# Polk Avenue Sidewalk Project

Alex Carroll  
Complete Streets Program Manager  
City of Alexandria  
July 2022

# Proposed Sidewalk – Draft Concept

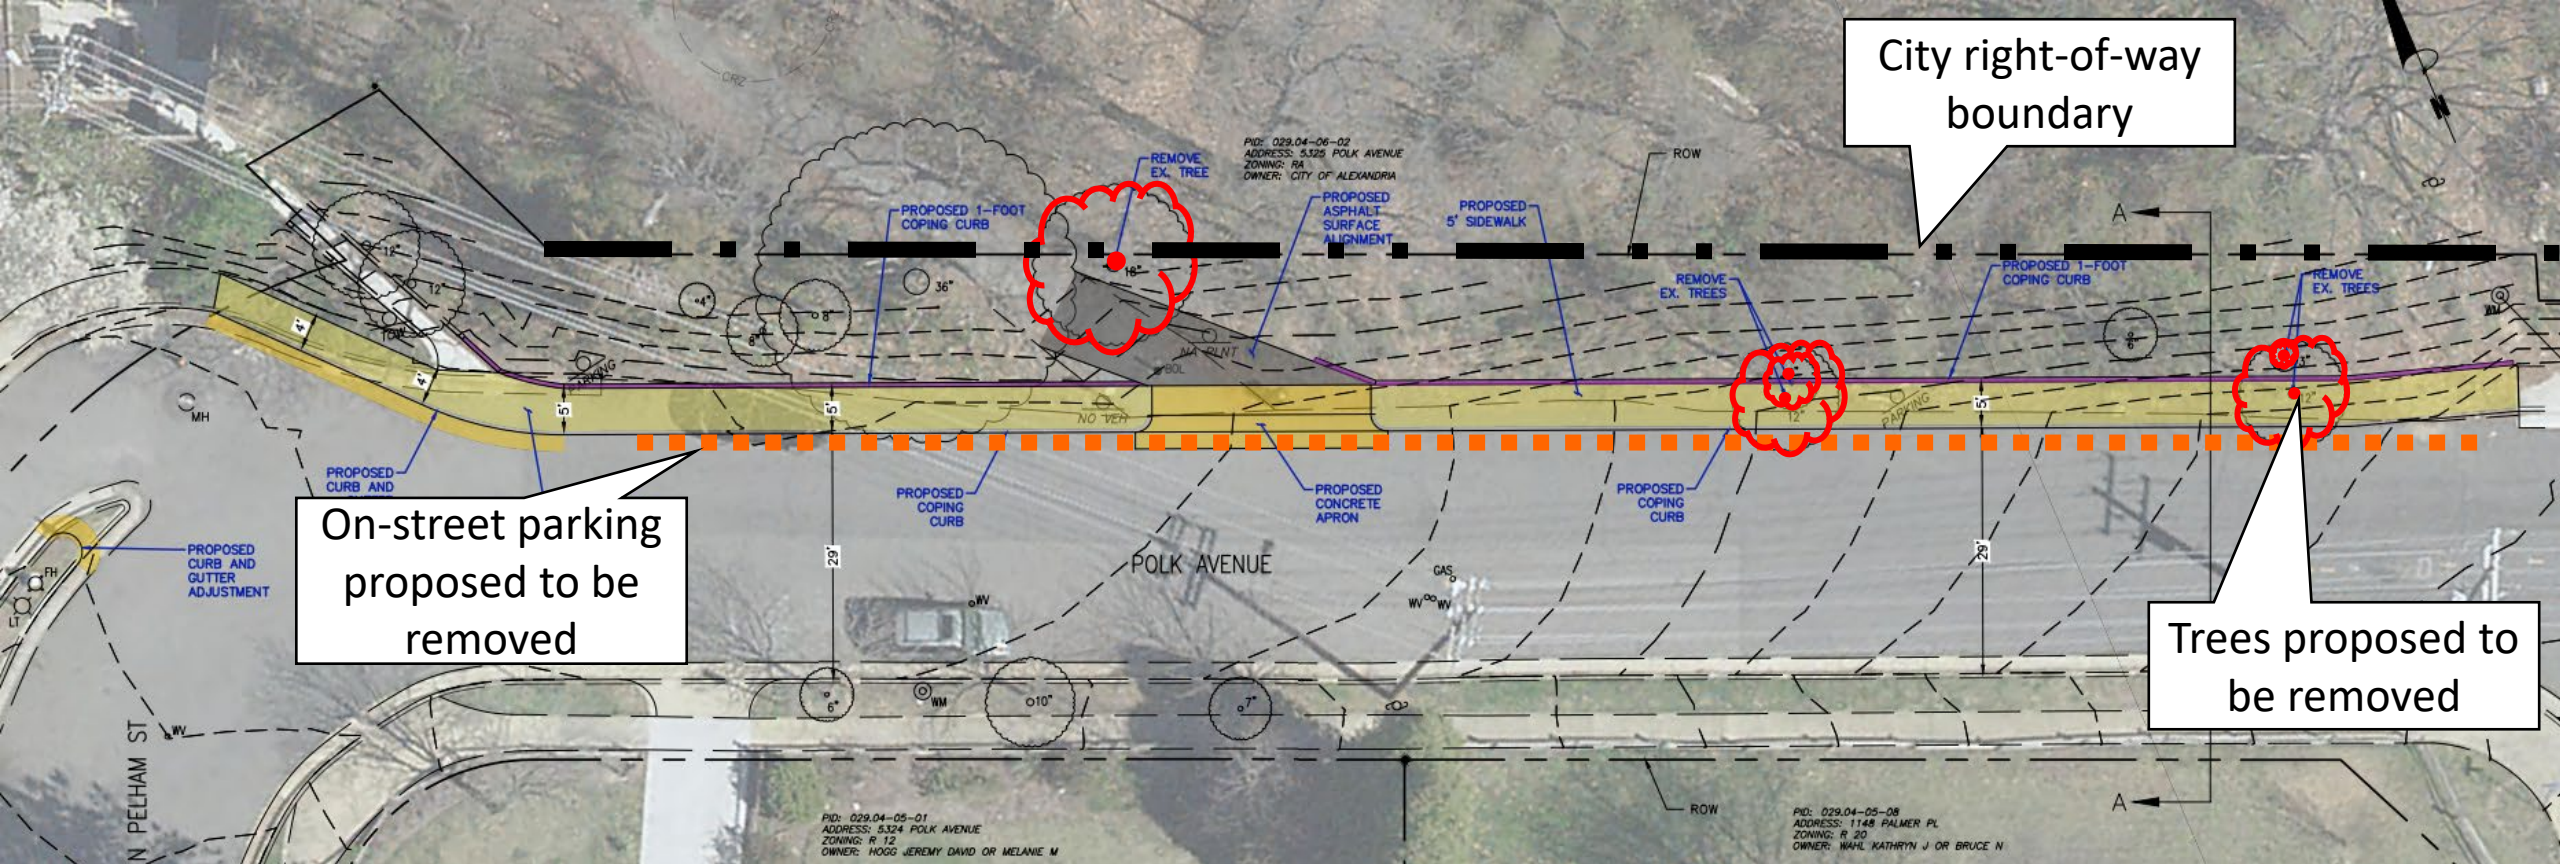
- 4-5' wide sidewalk to fill existing sidewalk gap
- Within City street right-of-way
- Largely on existing street footprint (60%)
- 5 trees would require removal (18", 12", 12", 6", 3")
- 9 parking spaces would require removal

# Revised Concept Based on Community Feedback

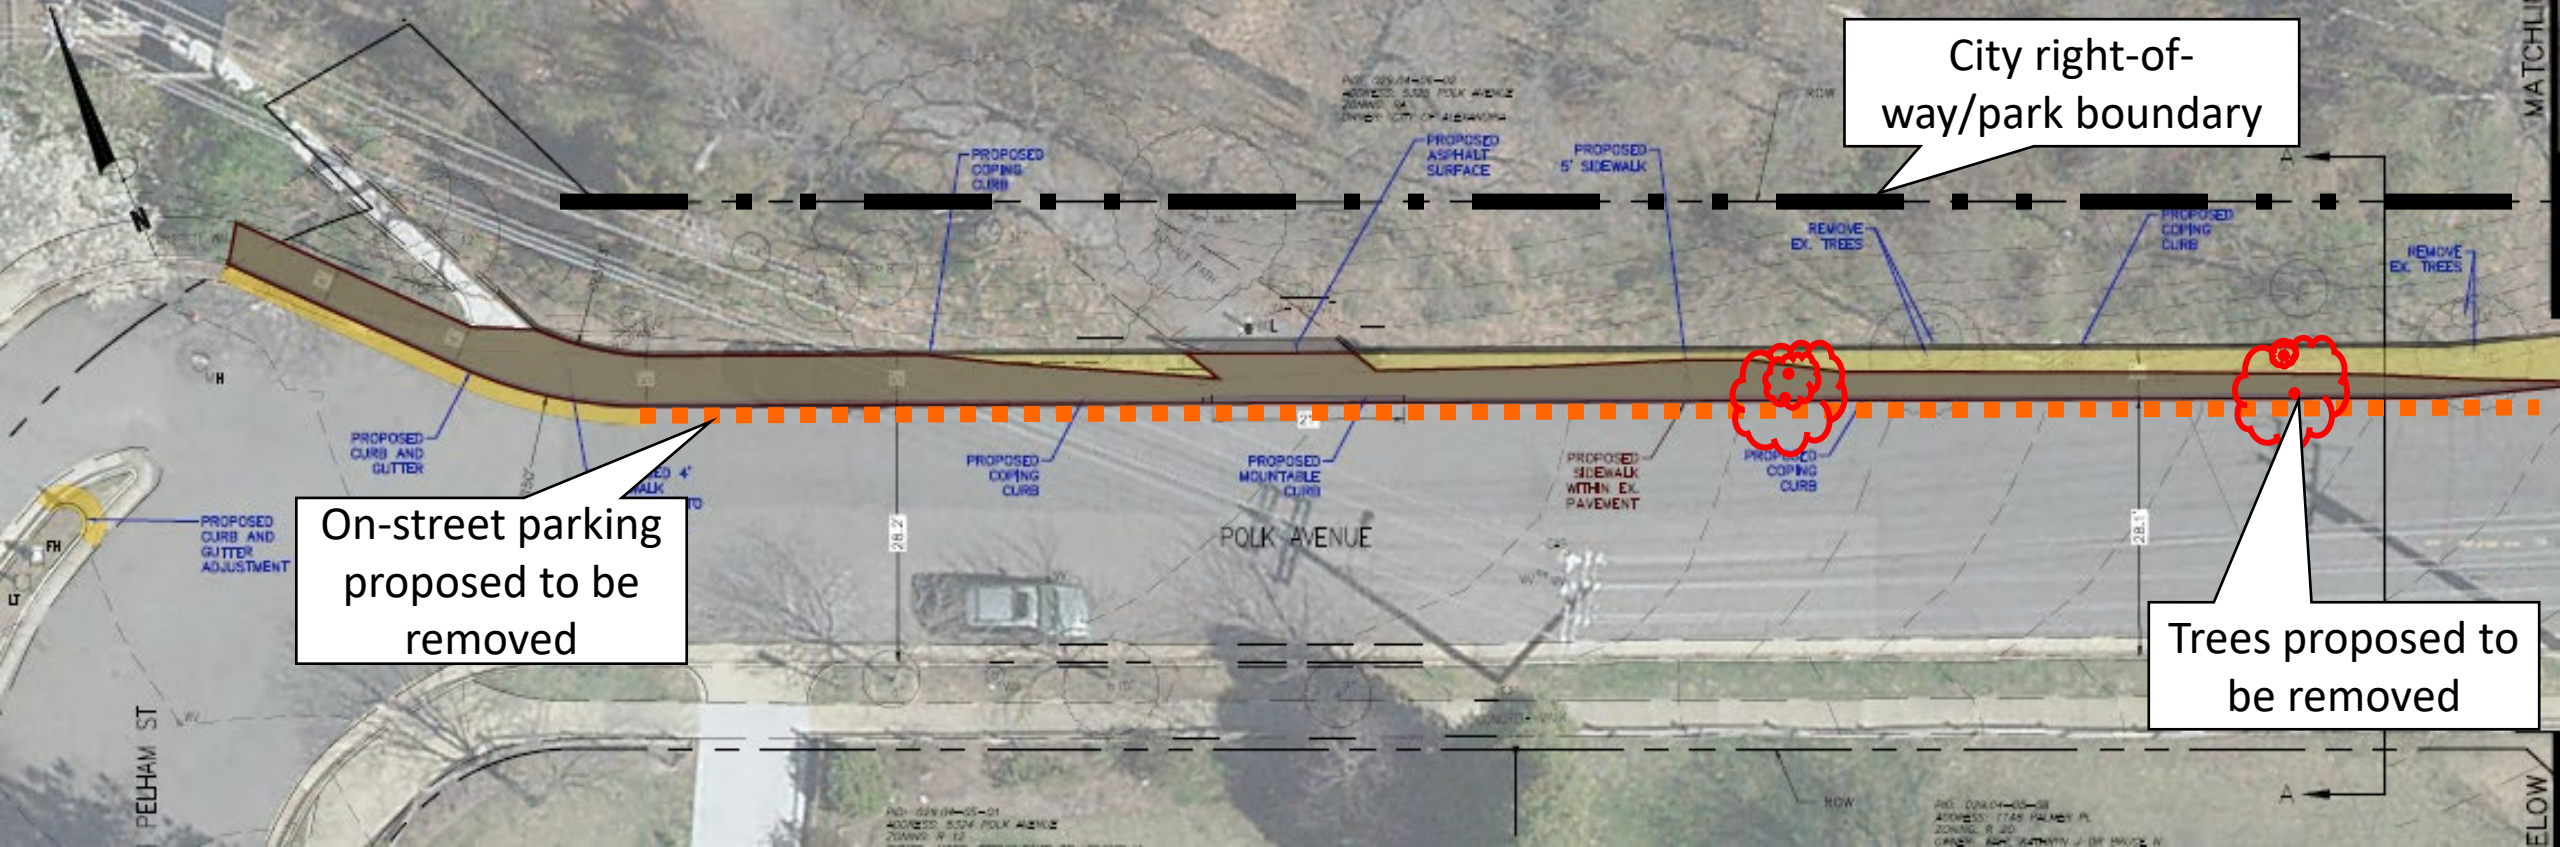
## **Impact to park space**

## **Impact to trees**

## **Impact to parking**

## **Request for crosswalk**

## **New impervious surface**

## **Stability of park**

*Sidewalk is entirely within public right-of-way and not within the open space*

*Staff have revised plans to avoid impacting largest tree*

*Sufficient parking is available via on-street parking and private driveways*

*Crosswalks can be provided at Palmer Pl, but sightlines are insufficient for a crosswalk at Pelham St*

*Majority of proposed sidewalk would be installed on existing paved area*

*Staff have determined a max 1' curb is sufficient retention between hill and sidewalk to maintain stability*

- 4-5' wide sidewalk to fill existing sidewalk gap
- Within City street right-of-way
- **Predominantly on existing street footprint (82%)**
- **4 trees would require removal (12", 12", 6", 3")**
- **9 parking spaces would require removal, + up to 6 additional spaces if new crosswalks are included**
